Flood Control Project Maintenance
Levee Inspections

Maintenance Issue Types Only, Levee Inspection Report By Mile - Spring 2017

Reclamation District No. 0556 Upper Andrus

Waterway	Bank	Unit Miles	Inspection Start/End	Inspector
Unit No. 01 Georgiana Slough	Right	5.48	04/19/2017 04/19/2017	Herman Phillips

Photo 1 of 1 : SP_2017_RD0556_18_74_20170517_00060.jpg

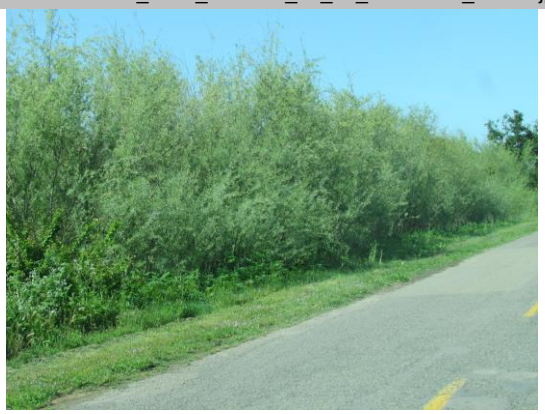
This arundo needs to be removed, this vegetation completely blocks the view of the waterside slope, shoulder and toe.

Photo 1 of 1 : SP_2017_RD0556_18_1_20170404_00001.jpg

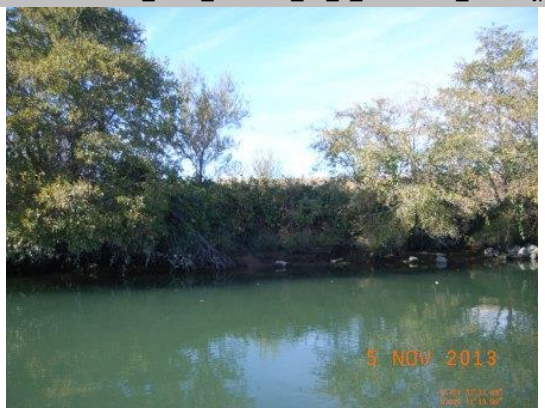
1997 - Toe damaged rock. 1999 - One pocket filled with gravel. 2000 - Eroding beach with some biotech rolls and stakes; some gravel on slope. 2001 - Staked, low fascine walls at bankline. 2005 - Stone revetment in between pockets. 2006 - New rock on upper slope behind brush boxes at the upstream end, Stone is sliding off the hard toe. 2015: Last observed in 2013. [2015 Site ID: GEO_7-0_R]

Photo 1 of 1 : SP_2017_RD0556_19_29_20170523_00054.jpg

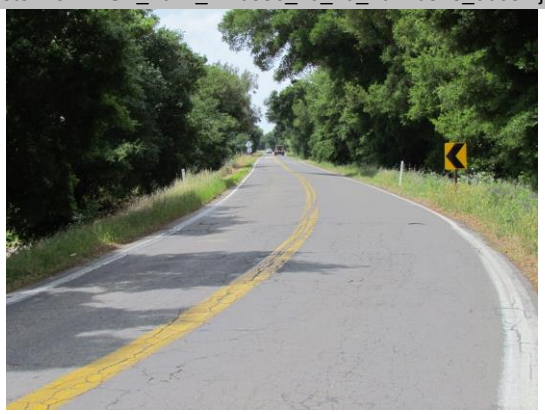
Control the wild vegetation and wild tree growth from the landside slope and shoulder heading downstream

Photo 1 of 1 : SP_2017_RD0556_19_82_20170404_00015.jpg

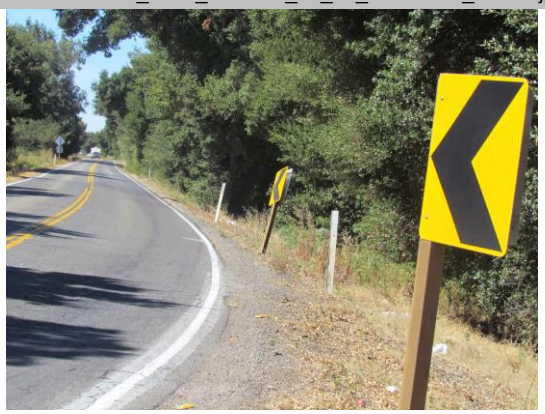
Waterside levee slope and shoulder is covered with wild tree growth and other unsatisfactory vegetation.

Photo 1 of 1 : SP_2017_RD0556_19_12_20170404_00010.jpg

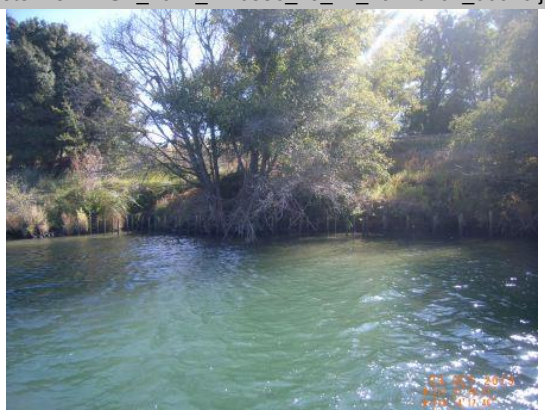
2002 - Two rocked sections (150 ft long) at the downstream end. 2005 - Lots of old brush boxes, some with established vegetation in the area behind the boxes. 2006 - Some small spots fixed with stone. 2009 - Minimal new erosion, rock in the middle of the reach may be new. 2011 - Minor new erosion at the toe. 2013 - Minor new erosion. 2015: Site is currently under construction. [2015 Site ID: SAC_26-0_L]

Photo 1 of 1 : SP_2017_RD0556_19_11_20170404_00009.jpg

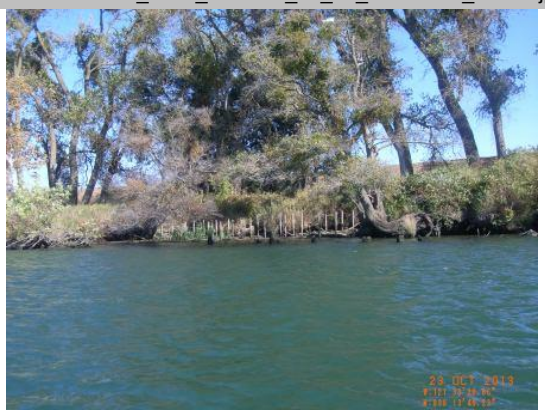
1997 - Few scallops in berm, some getting close to levee toe. 2005 - Brush boxes present. 2012 - More erosion of the toe since last year. 2015: No observed changes. [2015 Site ID: SAC_23-3_L]

Photo 1 of 1 : SP_2017_RD0556_19_10_20170404_00008.jpg

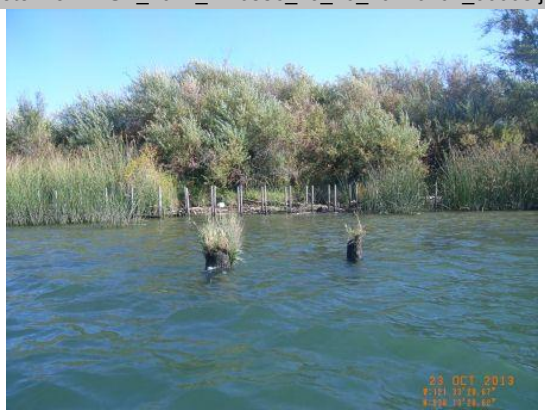
2000 - Recently fallen cottonwood at the downstream end. 2005 - Empty brush boxes. 2011 - A few trees have fallen since last year. 2012 - Potential new tree popout since last year. 2013 - New erosion at downstream end of site and a recent tree pop-out observed. 2015: No observed changes. [2015 Site ID: SAC_23-2_L]

Photo 1 of 1 : SP_2017_RD0556_19_8_20170404_00007.jpg

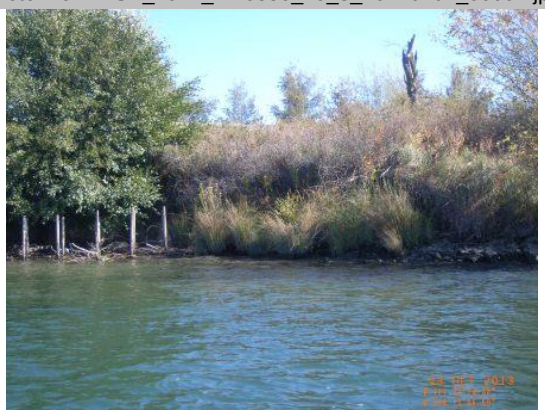
1997 - Scallops into berm and very close to levee toe. 2005 - Brush boxes present. 2011 - New toe scour and freshly fallen tree. 2012 - New tree popout has taken significant portion of soil out of the levee. 2015: No observed changes. [2015 Site ID: SAC_22-7_L]

Photo 1 of 1 : SP_2017_RD0556_19_3_20170404_00003.jpg

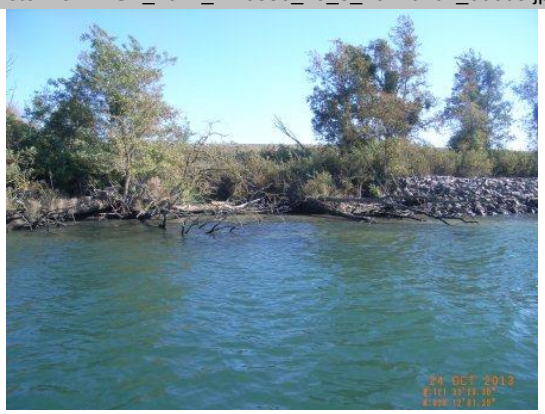
1999 - Downstream 140 ft repaired with rock. 2010 - Lots of woody debris, but no changes to site. 2015: Site extended upstream due to erosion pockets. [2015 Site ID: SAC_21-5_L]
